COMMENTS ON LOCAL PLAN REVIEW – LOW CARBON POLICIES – OCTOBER 2019

Jules Stringer on behalf of ACT Built Environment group <u>TeignbridgeCE@gmail.com</u> Or jules@oakhousedaracombe.co.uk

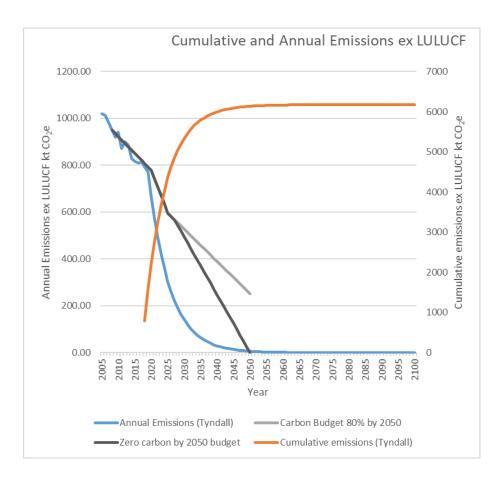
The statement that "Nationally, the Climate Change Act 2008, as amended, contains legally binding targets for the UK to bring all greenhouse gas emissions to net zero by the year 2050" is correct. However it's interpretation of a linear reduction in annual emission targets is not in line with the government's <u>Carbon Budget targets</u>, also a legal requirement.

The 2008 Climate Change act also requires that "To meet these targets, the government has set fiveyearly carbon budgets which currently run until 2032. They restrict the amount of greenhouse gas the UK can legally emit in a five year period". We are currently in the 3rd five-year budget period which ends in 2022.

Although there are several ways in which the remaining Carbon Budget for Teignbridge can be allocated between now and 2050, practically the majority of the GHG emission reductions must be front loaded. That is a steeper initial reduction in annual targets as it will become progressively more difficult to reduce emissions completely as we approach Zero Carbon.

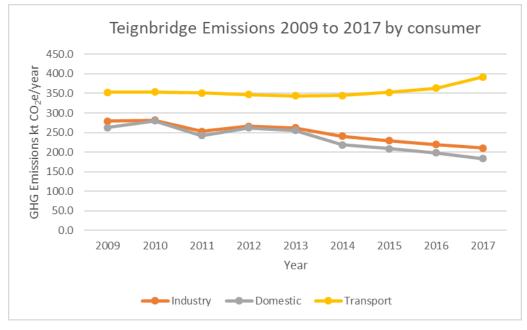
The policies do not address issues related to where buildings are built. The local plan 2013-33 covered housing allocation. Transport emissions represent 50% of Teignbridge emissions. Unlike domestic and industrial emissions, transport emissions are still rising.

Though EVs will play a part in reducing transport emissions, 100% EVs and the current level of private car travel is not deliverable because of network constraints. This means that the need for private car travel is addressed. The previous policy aspires to do this, but has not had the desired effect. In reality Exeter is a centre to which many residents commute, so one way of reducing car commuting in the district would be to build more of the required housing allocation near to Exeter, as opposed to in the Heart of Teignbridge.
